DEVIATION REQUEST AND DECISION FORM

Project Name :	Crossroads North
Schedule No.(s) :	5408001008, 5408001029, 5408001032, 5408001033, 5408001034, 5408001041, 5408001042, 5408001050, 5408001051, 5408001052
Legal Description :	Lots 12, 13, 14, 15, 16 and 18, Hillcrest Acres, according to the plat thereof recorded May 12, 1960 at reception No. 153860, except that portion acquired by the department of Transportation, State of Colorado as described in rule and order recorded April 28, 2004 under reception no. 204068322, and except those portions conveyed to El Paso County by and through the Board of County Commissioners of El Paso County, Colorado by special warranty deed recorded December 17, 2014 at reception No. 214116021 and recorded December 17, 2014 at reception No. 214116022, County of El Paso, State of Colorado, Lot 17, Hillcrest Acres, County of El Paso, State of Colorado, except that portion conveyed to El Paso County by and through the Board of County Commissioners of El Paso County, Colorado by special warranty deed recorded December 30, 2014 at reception No. 214119767. Lot 19, Hillcrest Acres, County of El Paso, State of Colorado, as amended by surveyor's statement recorde

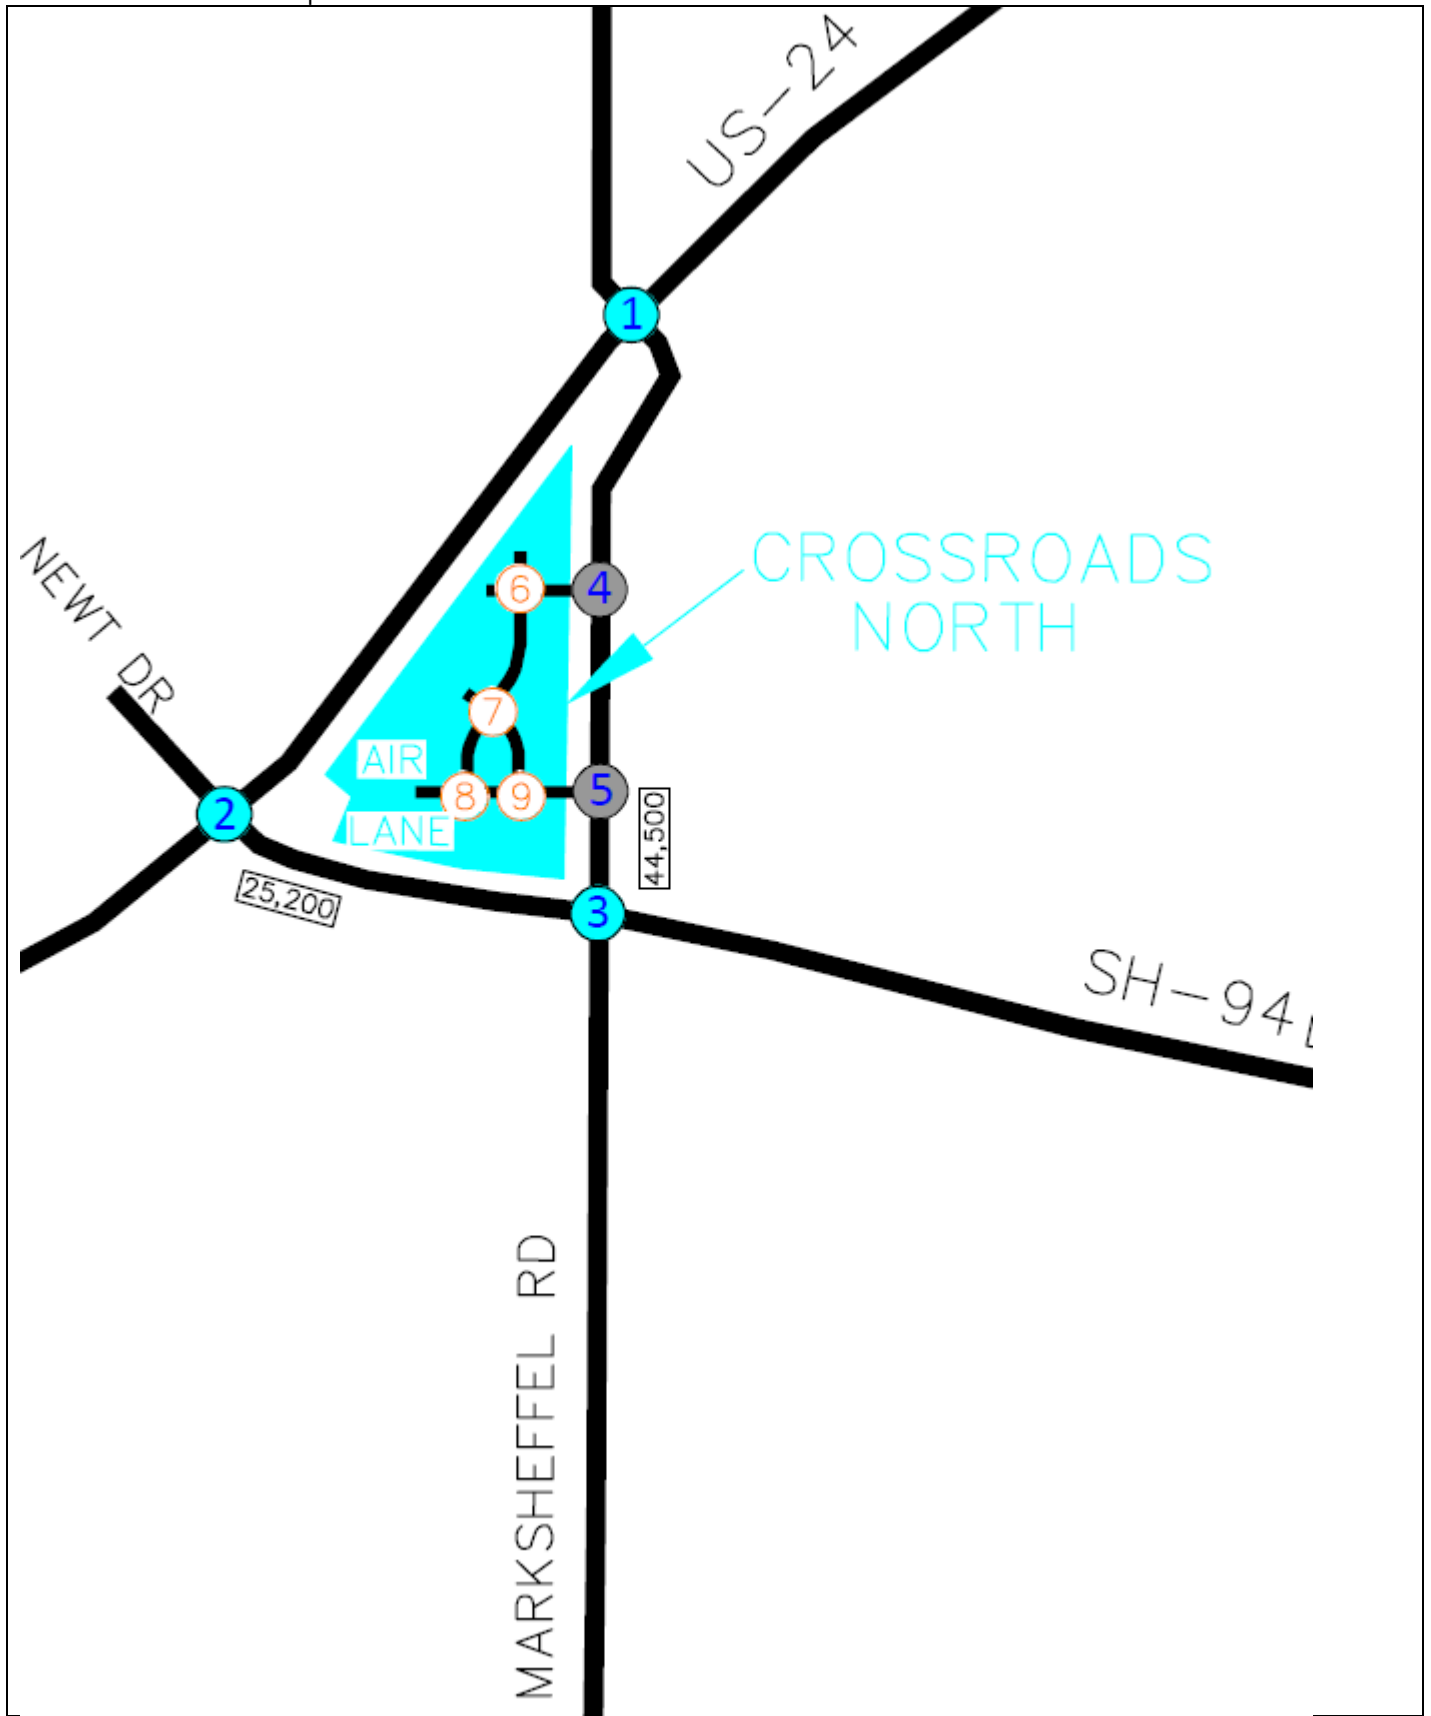
Deviation Request to be withdrawn.

After the last submittal review (Review #2) Marksheffel Road was deeded to the City of Colorado Springs for ownership/maintenance. Coordinate with City of Colorado Springs for their requirements.
